**Service Bulletin**

**No. :** MZ05-009

**Model:** ER2500

**Subject:** If the video equipment connected to the ER2500 does not have a coupling capacitor the units will not sync properly.

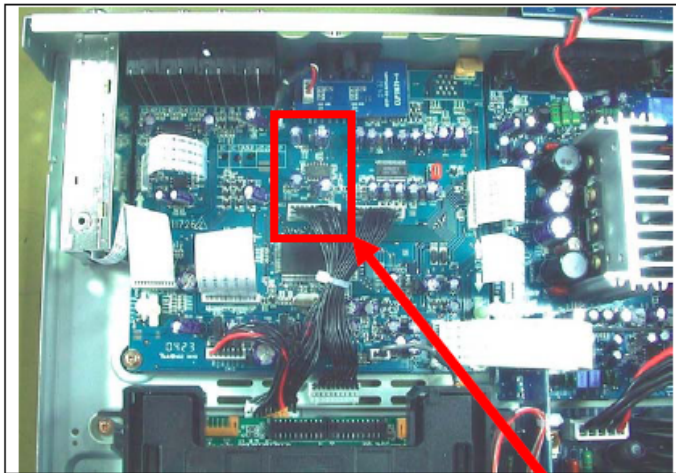
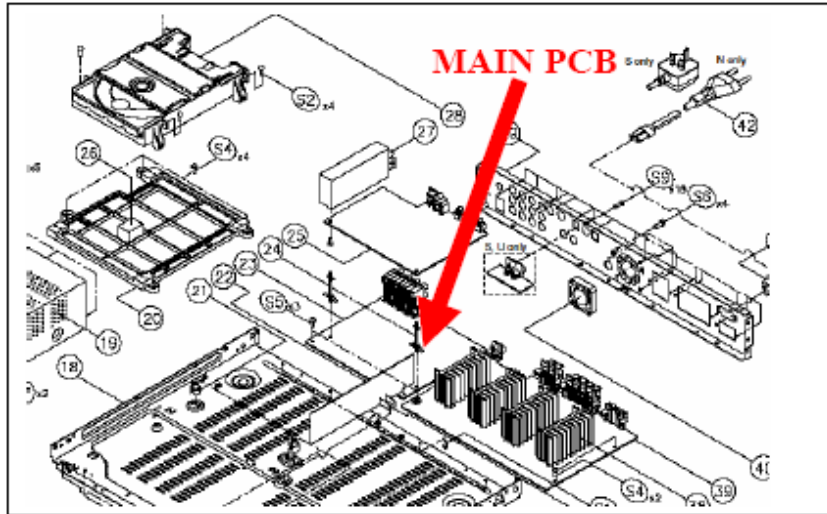
**Symptom:** The following 6 parts have been changed on the MAIN PCB.

- Solution:**
1. C531 CHIP ELECT. CAPACITOR (100uF 16V) is changed to (33uF 16V).
  2. C537 CHIP ELECT. CAPACITOR (100uF 16V) is changed to (33uF 16V).
  3. CARBON FILM FIXED RESISTOR (75 OHM +-5% 1/6W) is added.
  4. CARBON FILM FIXED RESISTOR (75 OHM +-5% 1/6W) is added.
  5. R525 CHIP RESISTOR (75 OHM) is removed.
  6. R530 CHIP RESISTOR (75 OHM) is removed.

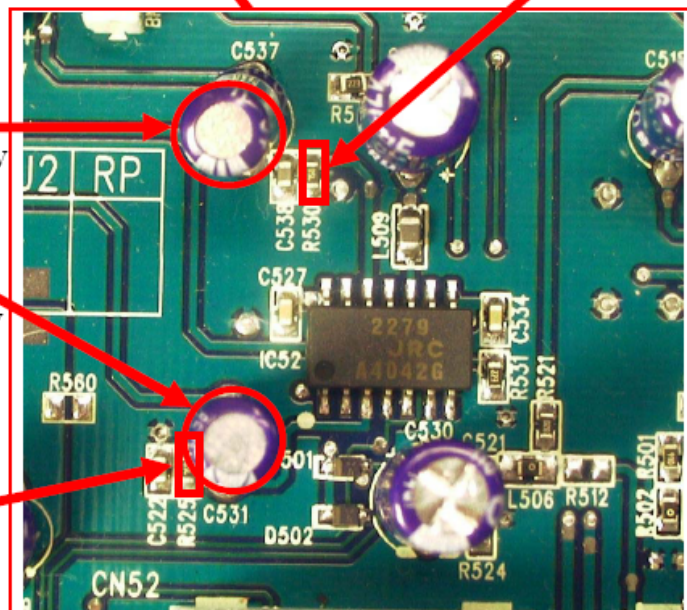
Remove **R530**

**C537**  
100uF/16V is changed to 33uF/16V

**C531**  
100uF/16V is changed to 33uF/16V

Remove **R525**
